ADDENDUM NO. 3

LAKE PRAIRIE ELEMENTARY SCHOOL - CLASSROOM ADDITION Lowell, IN 46356

ADDENDUM NO. 3 (THREE)

DATE: July 13, 2023
PROJECT: Addition to Lake Prairie Elementary School
OWNER: Tri-Creek Community Schools
PROJECT NO.: 2022071.00

Client Project No:	
	VPS Project No:	2022071.00
	Project Issue Date:	JUNE 2023
	Drawing No:	ED-101

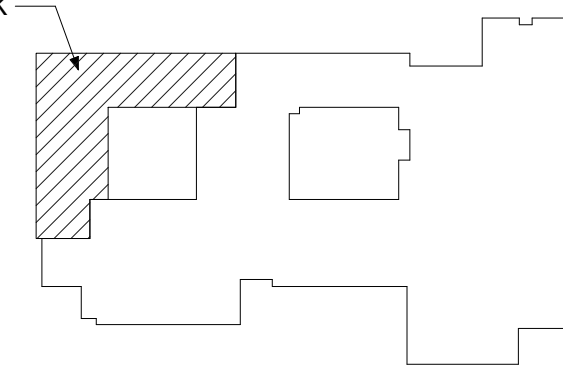
- 3-12 ED-101: Replace drawing in its entirety with attached revision (added demolition receptacle and cameras; clarified canopy location).
- 3-13 E-101: Replace drawing in its entirety with attached revision (removed EA fixtures; removed display case switches; revised display case lighting circuitry; revised note location).
- 3-14 E-102: Replace drawing in its entirety with attached revision (added General Notes; revised camera locations; removed exterior speakers; removed duplex data outlets).
- 3-15 E-200: Replace drawing in its entirety with attached revision (removed low-voltage connections from Teachers Station/TV Detail).
